BAROSSA ASSESSMENT PANEL

AGENDA

6.1 25011361 - 37 Moppa Road South Nuriootpa

PROPOSAL	Truck and trailer parking facility (expansion of existing road transport terminal) with associated four (4) security lighting towers (up to 6 metres in height) and acoustic earthen mound (up to 1.5 metres in height) with an acoustic fence sited atop (2 metres in height) and associated altered internal driveway, stormwater management and landscaping area
APPLICANT	Scott Butler
OWNER	Hahn Corporation
APPLICATION NO	25011361
CERTIFICATE(S) OF TITLE	CT 6023/382
AREA	Approximately 8.7 hectares
CURRENT USE	Road transport terminal (truck and trailer parking facility)
PLANNING AND DEVELOPMENT CODE VERSION	Version 2025.9 – 15 May 2025
PLANNING AND DESIGN CODE EXTRACT LINK	Relevant Code Extract
ZONE	Employment Zone
OVERLAYS	Character Preservation District Hazards (Bushfire – Medium Risk) Hazards (Flooding - Evidence Required) Native Vegetation Prescribed Water Resources Area Traffic Generating Development Water Protection Area Water Resources

Sheet Size	A2
Date	4/11/25
Scale	As indicated
Drawn By	SB
Job No	320-24
Sheet	S2
Phase	PL
Issue	6

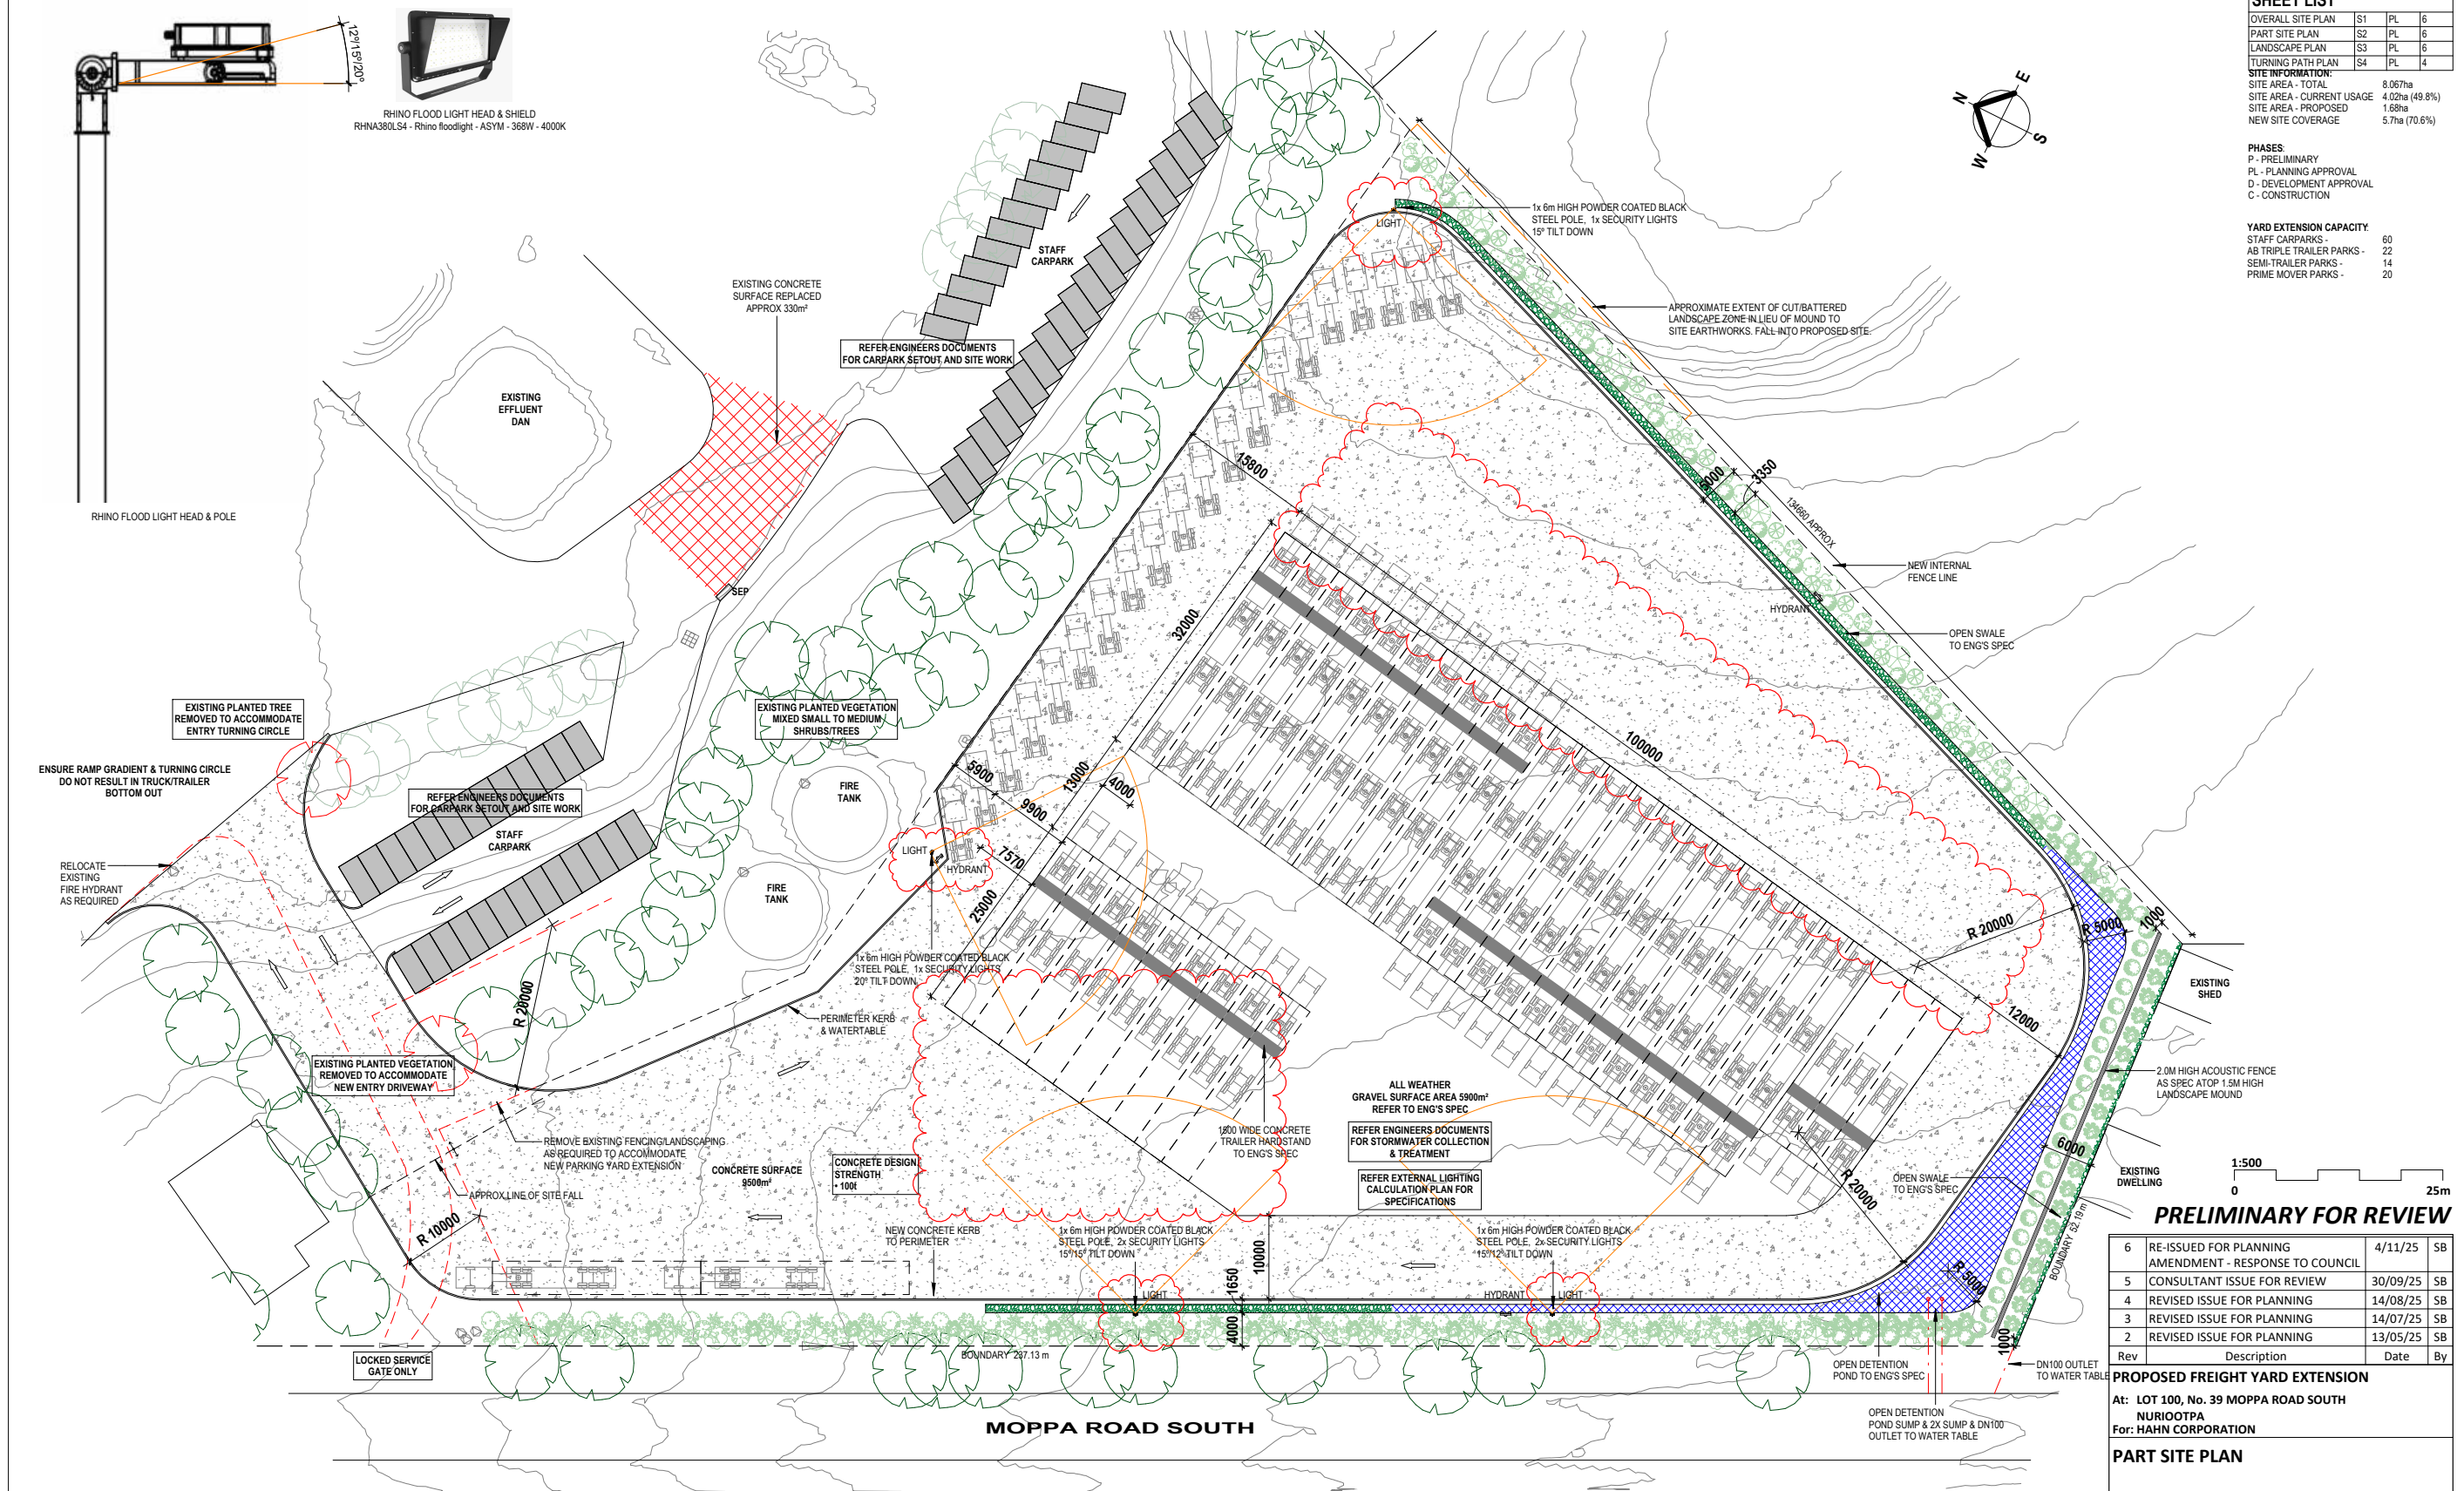
1. Site Plan
 - a. Please refer to drawing 320-24-S3 PL2
 - b. Please refer to drawing 320-24-S1 PL2
 - c. Please refer to separate amended Gama engineering drawing set, additional level information added.

- d. Please refer to separate amended Gama engineering drawing set
2. Please refer to drawing 320-24-S2 PL2
3. Please refer to drawing 320-24-S3 PL2
4. Please refer to drawing 320-24-S2 PL2 – the existing vegetation to be removed was planted by company to perimeter irrigated landscaping.

Required Information 1:

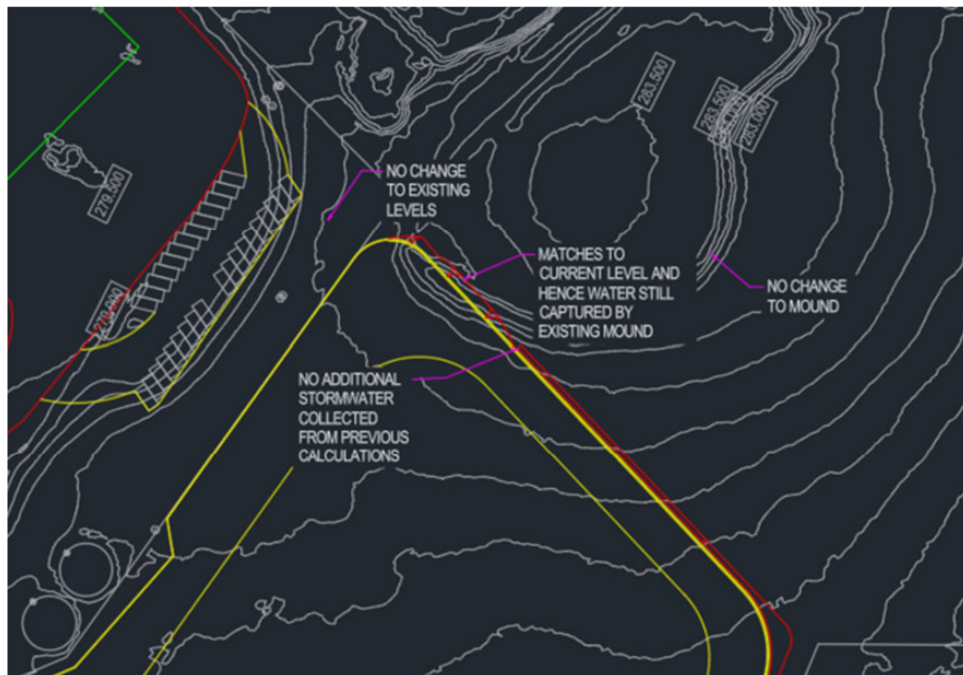
The existing mound is currently reducing the amount of water that run down the slope. It has a barrier on one side only and hence is a barrier not a detention basin. The new earthworks in the corner will still allow the existing level to remain with a batter. This will ensure that the mound is still working as it is currently, there is no additional water running into the new stormwater system than has been calculated previously.
